REGIS HOMES
 THE ISLANDS AT RIVERLAKE

Attachment D – Responses to Additional DEIR Comments

Islands at Riverlake
Responses to Additional Comments
SCH# 2002062103

EXHIBIT "B"
1 of 2

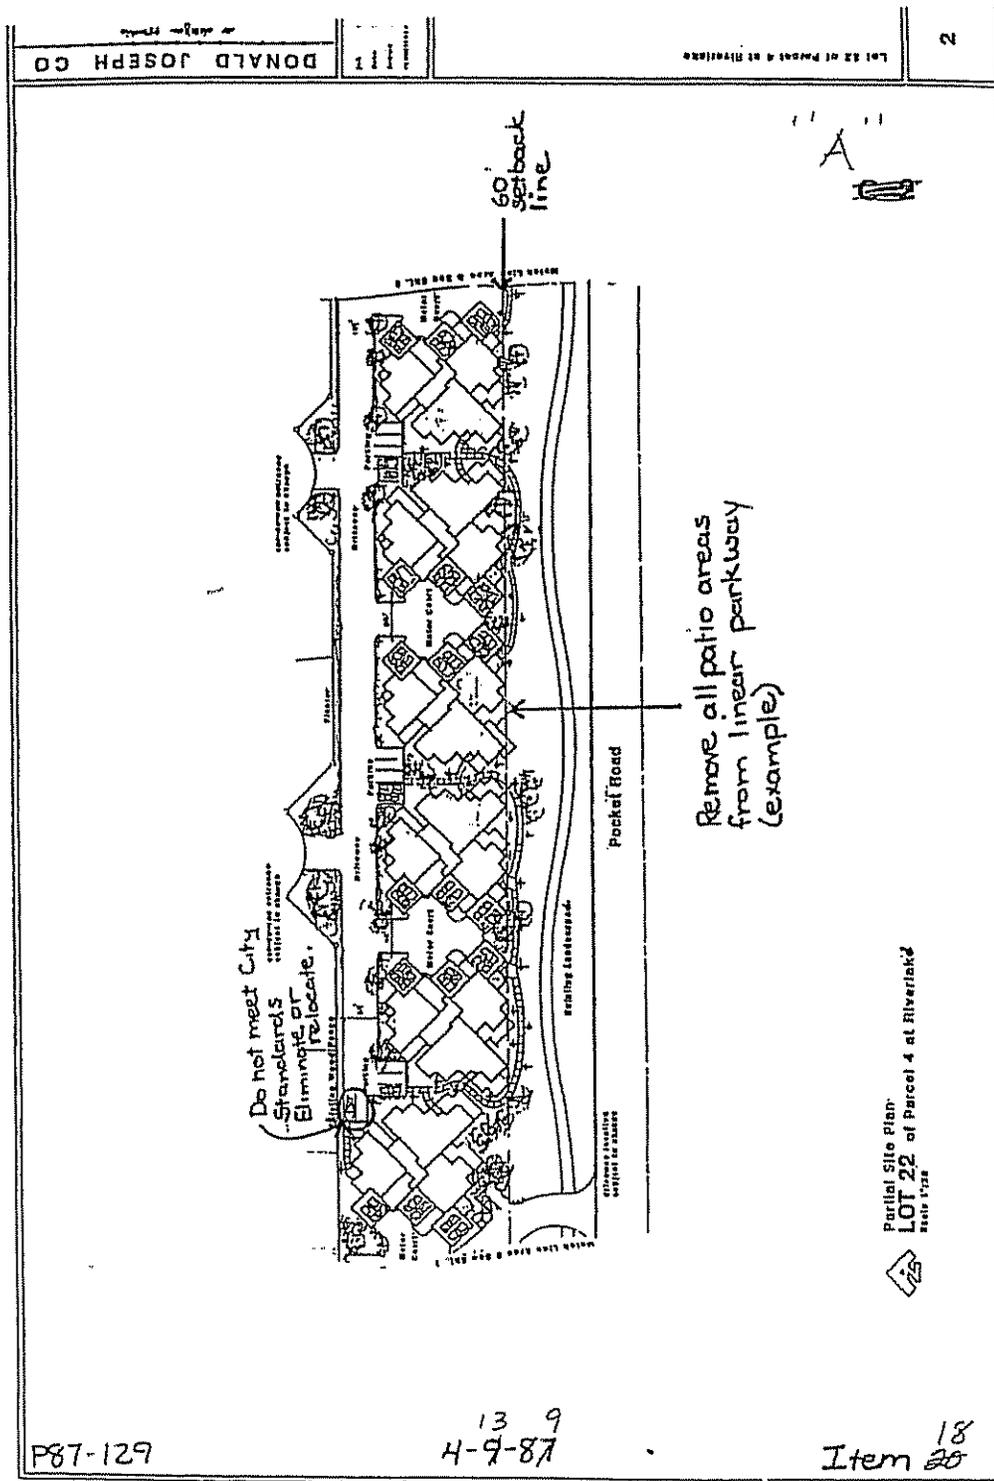
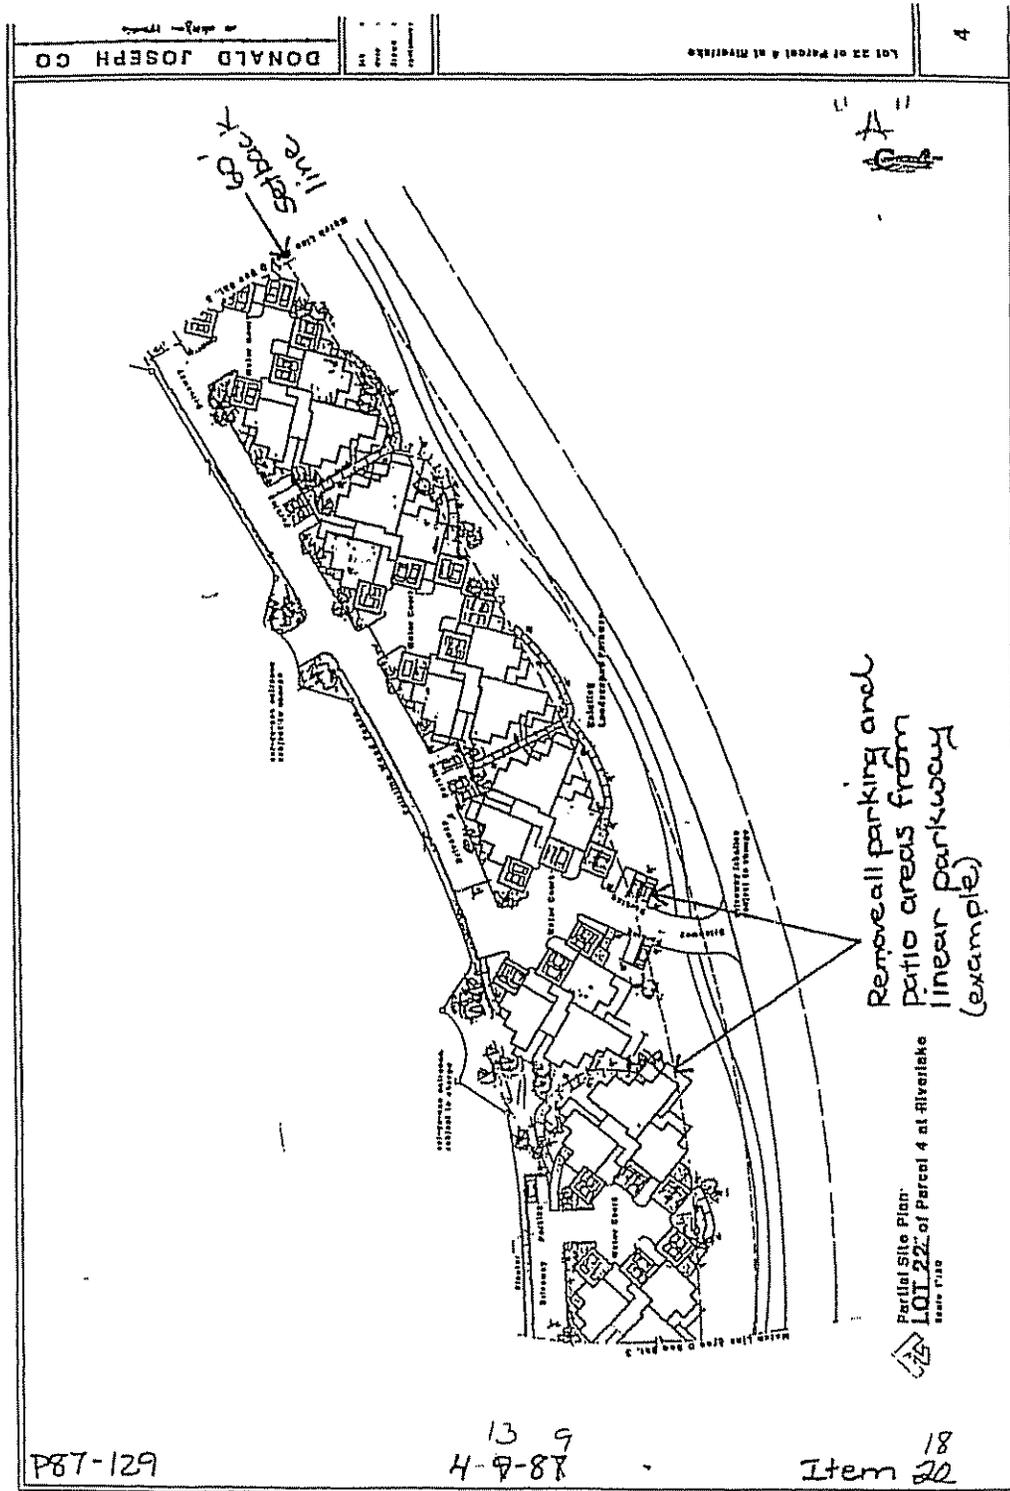
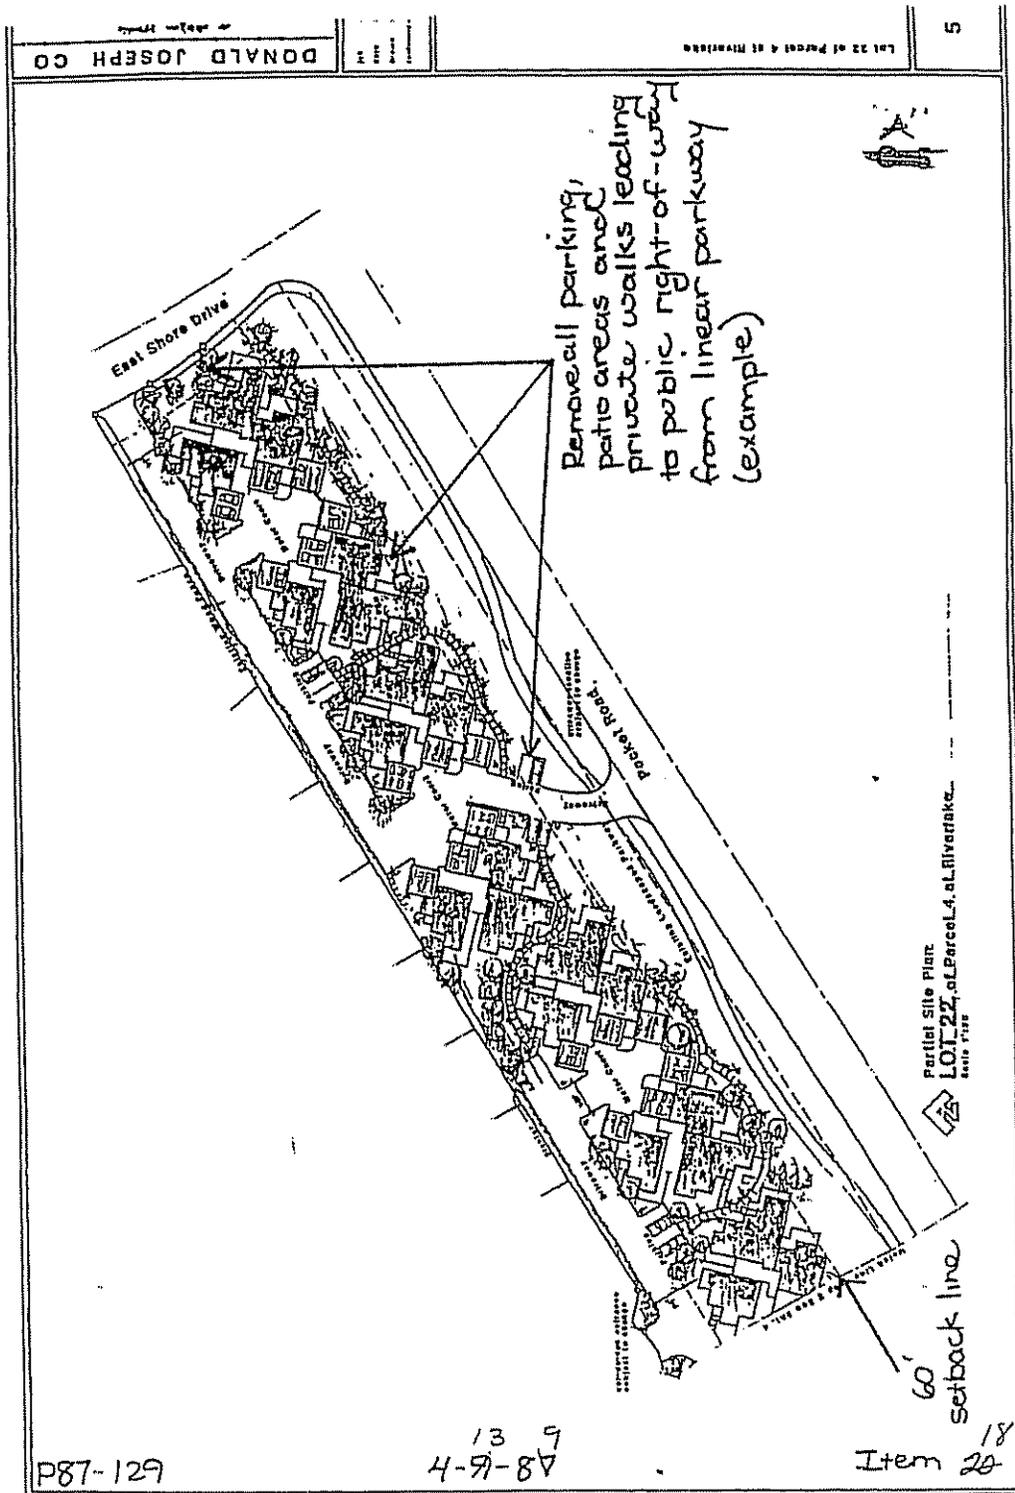
Project Denisty: (See Attached Exhibit "B")

Attached as an exhibit is a City of Sacramento Planning Dept. acreage analysis and resulting density calculations for your review. This analysis does not match up with data in the DEIR document, which allows readers to draw the wrong conclusions relative to density and impact to the community and is a major discrepancy.

The DEIR documents indicate a net acreage of 19.44 acres. The City Planning Department documented density factors for a January 27, 2003 community meeting indicates a net acreage of 12.23 net acres. What has been noted throughout the DEIR report indicating a density of 7.15 units per net acre. Isn't true that with a discrepancy of this magnitude many of the conclusions with reference to community impact are totally incorrect?

- 37-8 The net acreage was calculated consistently with Sacramento City Code 17.16.010 for the February 2005 Initial Study, the June 2005 DEIR, and the August 2005 FEIR. Please see Master Response 5. The sizes of the legal parcels were measured using AutoCAD functions. The gross acreage of the legal parcels is 21.44 acres. The ± 2-acre parkway easement to the City was subtracted from the gross acreage, in accordance with the definition of "net lot area"

in Sacramento City Code 17.16.010. Therefore, the resulting net acreage is 19.44 acres. When the LPPT PUD was approved, the gross acreage of the legal parcels was \pm 22.6 acres. The \pm 2-acre City parkway easement was subtracted for the resulting net acreage of 20.5 acres. The LPPT PUD Schematic Plan Map, which reports 20.6 acres for the project site, did not include the City parkway easement acreage. Since the LPPT PUD was approved, the gross and net acreage of Lot 21 was reduced due to a lot split for Dutra House and the public Dutra Bend Drive.

The formulation of net acreage presented in the 27 January 2003 meeting notes subtracted the acreage of the private street and the applicant-owned, Riverlake Community Association-held, landscape easement in addition to the acreage of the 25-foot wide parkway easement to the City. The formula for calculating net acreage in Sacramento City Code 17.16.010 does not subtract private roads and private easements. Therefore, the formulation of net acreage presented in the 27 January 2003 meeting was incorrect. The formulation of net acreage used in the 2005 Initial Study and EIR is the correct one.
